May 31, 2000
NRC-00-0042

Subject: Response to Request for Additional Information
on Technical Specifications Change Request Related to
Spent Fuel Pool Expansion at Fermi 2 (TAC No. MA7233)

**RESPONSE TO REQUEST FOR ADDITIONAL INFORMATION ON FERMI 2
RERACK LICENSE SUBMITTAL**

Stress-Strain Curves for concrete subjected
to triaxial compression *

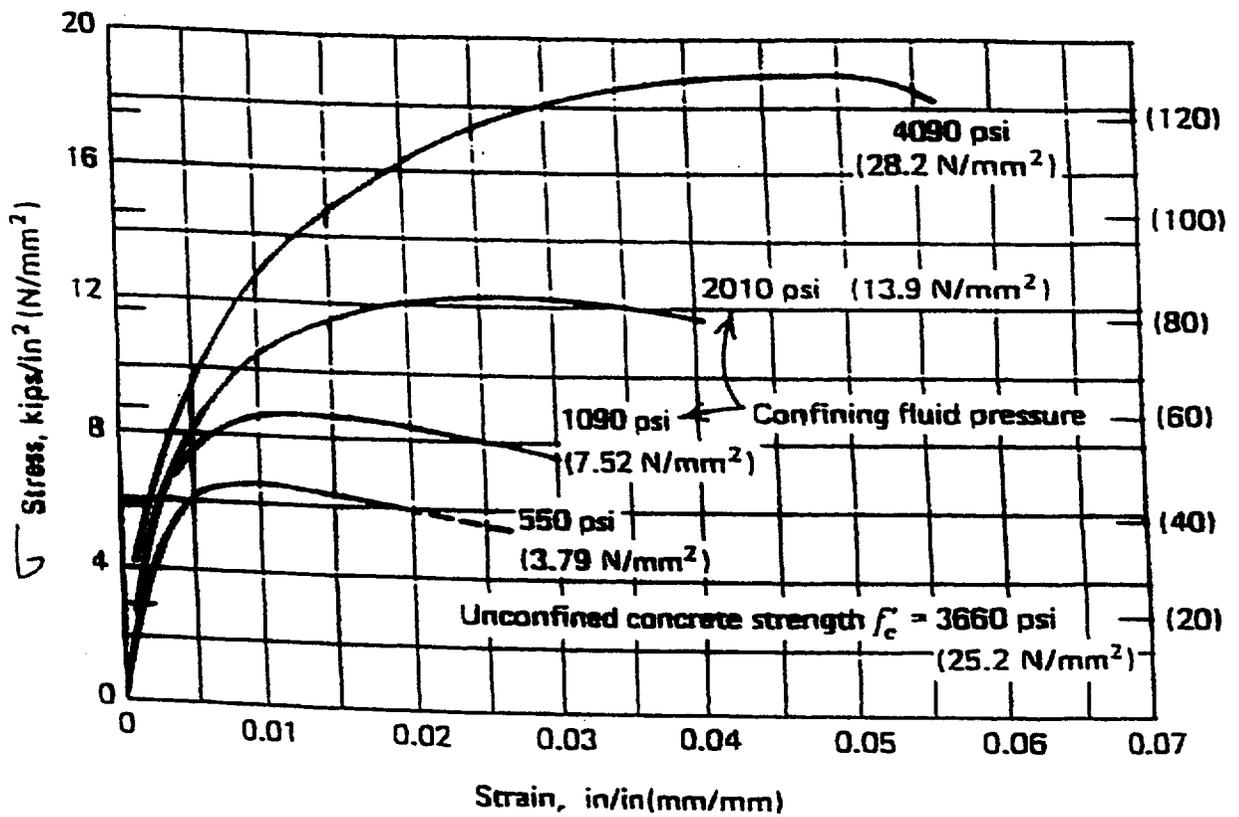
Section 7.5.3 "Deep Drop Event" in Enclosure 4 states that the maximum compressive stress in the concrete slab for a rack deep drop accident is 8.3 ksi, which is larger than the concrete compressive strength of 5.9 ksi. Under such conditions, explain the basis for your conclusion that substantial damage to the pool slab is not indicated.

The conclusion that the concrete slab sustains a localized crushing is based on a conservative assumption. The analysis conservatively uses a static compressive strength of the concrete, i.e., 5.9 ksi, as the failure limit of the concrete for a dynamic event such as the deep drop. In fact, the concrete failure limits for a dynamic event should be much higher than the static limit, as suggested by many credible textbook references. With regards to Fermi 2 spent fuel pool structure, the upper stratum of the pool slab supporting the stainless steel liner, which is laterally confined and simultaneously compressed from the interior of the pool water pressure, exhibits a triaxial compressive stress behavior, which reduces the tendency of internal cracking. This suggests that a stress-strain curve, which can accurately represent the triaxial behavior of the concrete slab, would be more appropriate for this analysis. Attachment 1 provides a plot of stress-strain curves for concrete subjected to triaxial compression, which has been taken from Park and Paulay's text (Reference 1). This stress-strain plot has been used as input in the drop accident analyses for several different nuclear plants including Union Electric's Callaway Plant, Wolf Creek Plant and Commonwealth Edison's Byron and Braidwood plants. Based on this plot, the concrete failure stresses are much higher than the unconfined compressive strength of 5.9 ksi. For example, A.M. Neville's textbook, "Properties of Concrete", (Reference 2) gives a failure stress of 14,700 psi for 3,500 psi concrete, which is consistent with Park and Paulay (Reference 1).

Therefore, although the concrete failure limit is much higher than 5.9 ksi, a conservative conclusion that the concrete slab is locally crushed was made in Section 7.5.3 of the Licensing Report based on the unconfined static compressive strength 5.9 ksi.

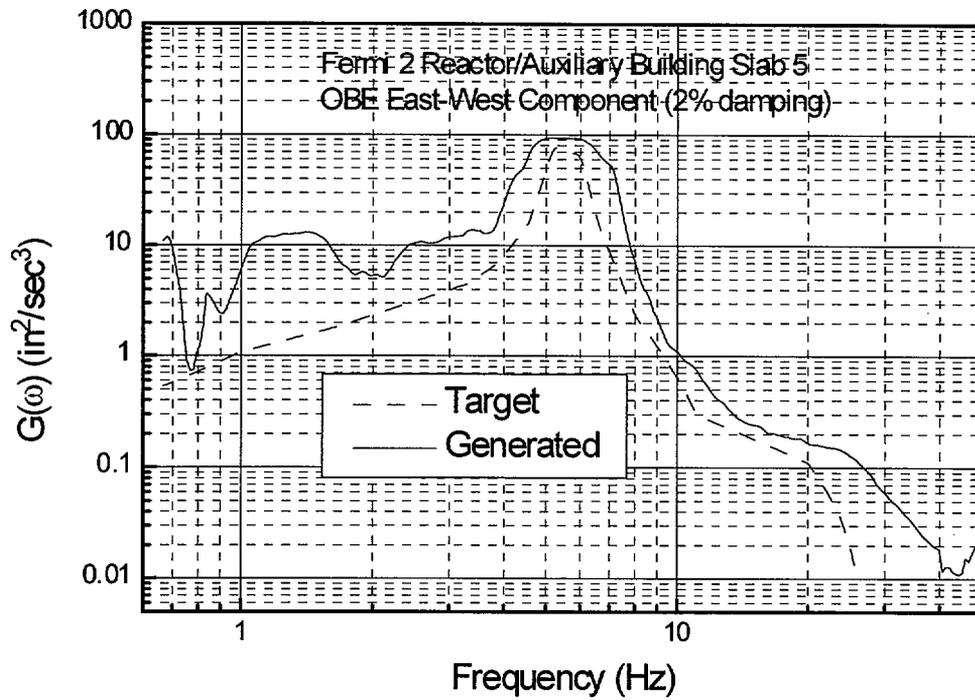
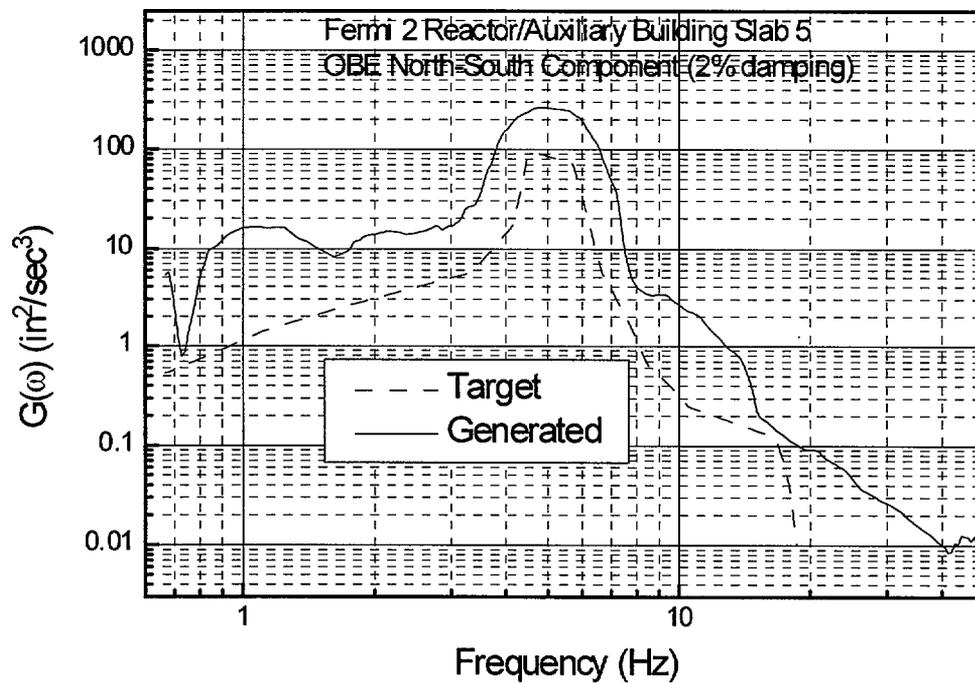
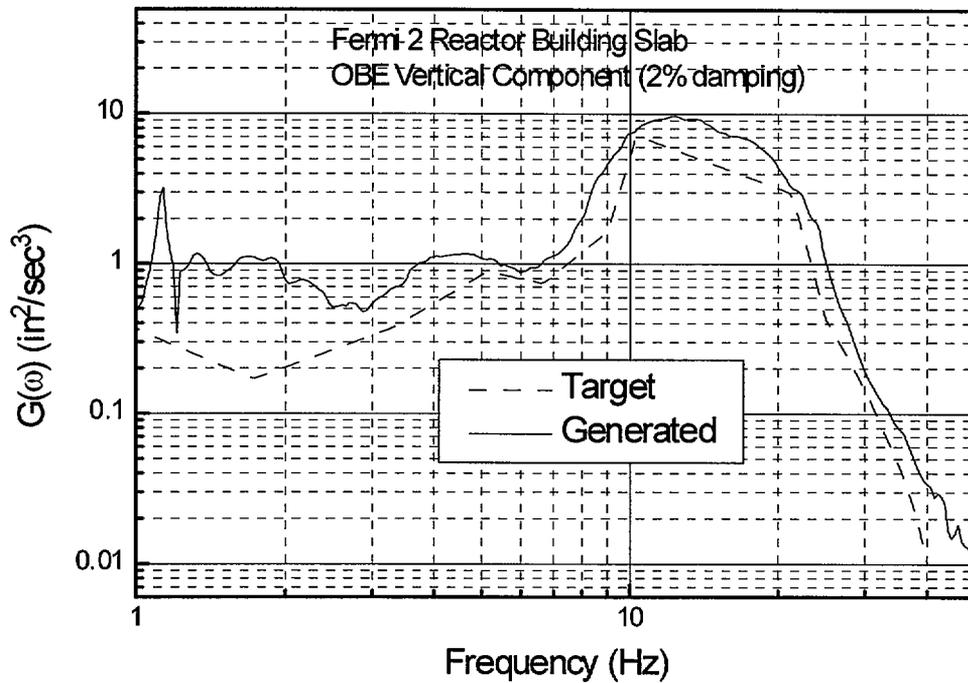
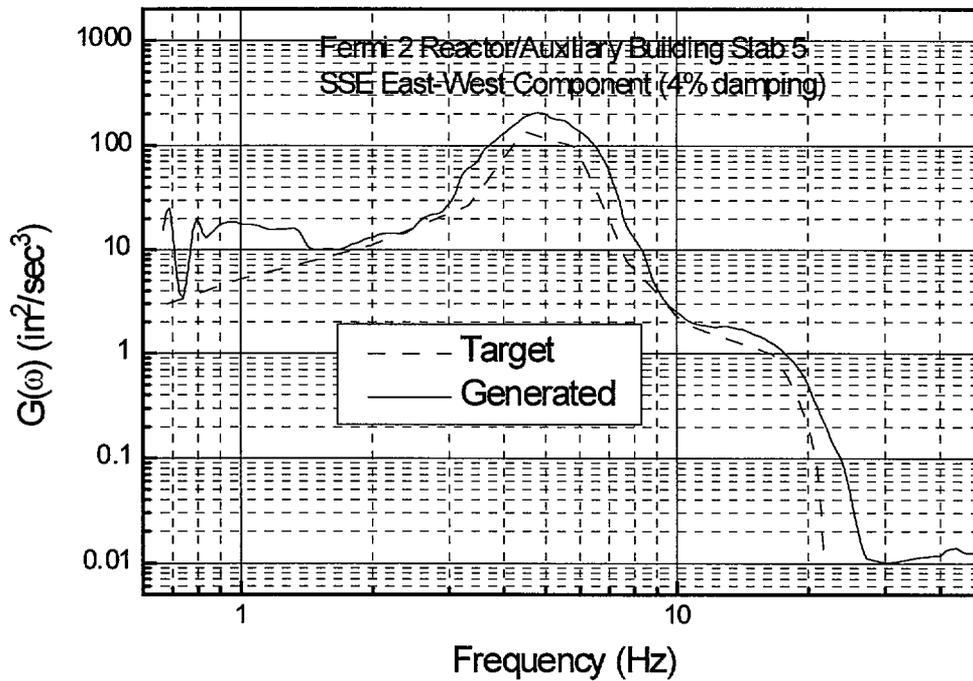
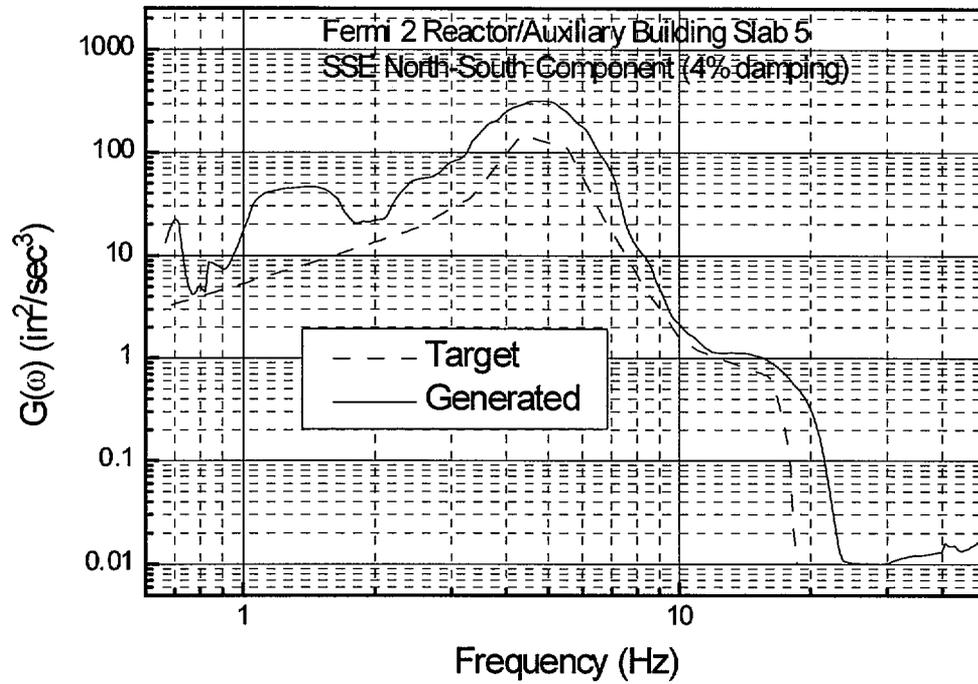
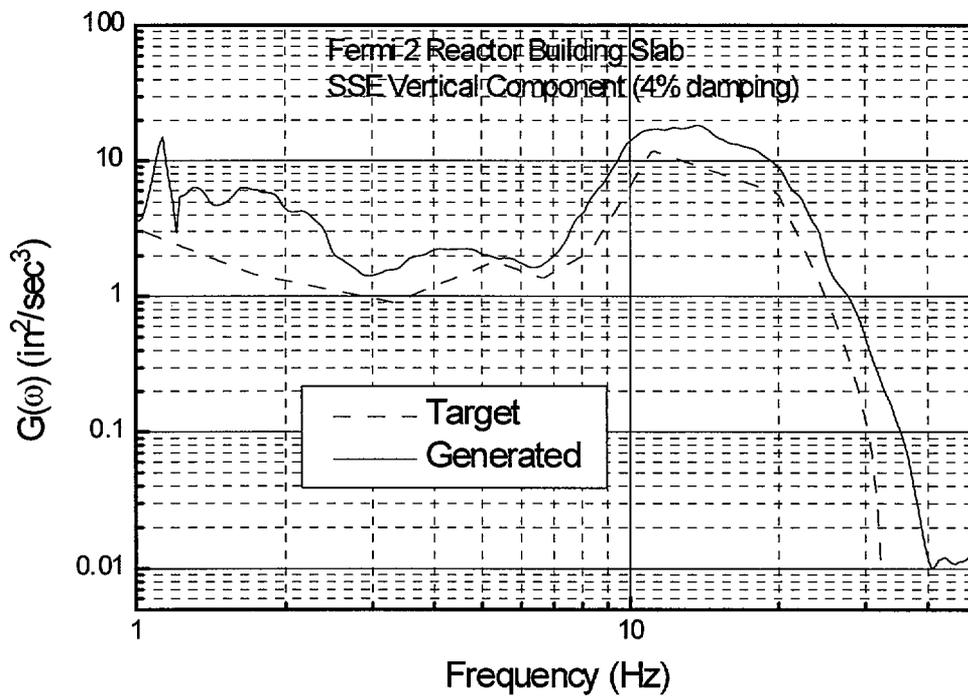
- (a) Explain how the target (design basis) response spectra (refer to in Section 6.4) were obtained. Also demonstrate that the synthetic time histories used in the analyses satisfy the power spectral density (PSD) requirements of SRP 3.7.1.
- (b) Provide the analysis results that show that the design criteria related to kinematic stability (i.e., safety factors against rack overturning) described in Chapter 2 of Enclosure 4 have been satisfied. Also, provide the dimensions of the gaps between the racks, and between the racks and the spent fuel pool (SFP) walls.

Two sets of artificial time histories were used in the structural analyses: a Safe Shutdown Earthquake (SSE) and an Operating Basis Earthquake (OBE). These synthetic time histories are statistically independent with their cross correlation coefficients less than 0.15. Furthermore, they satisfy the response spectrum and PSD enveloping requirements of SRP 3.7.1. Figures 1.1 through 1.6 provide a comparison of the PSD curves associated with the generated time histories and the PSD curves associated with the design basis response spectra. These figures clearly show that the generated PSD curves envelope the target curves over the entire frequency range.
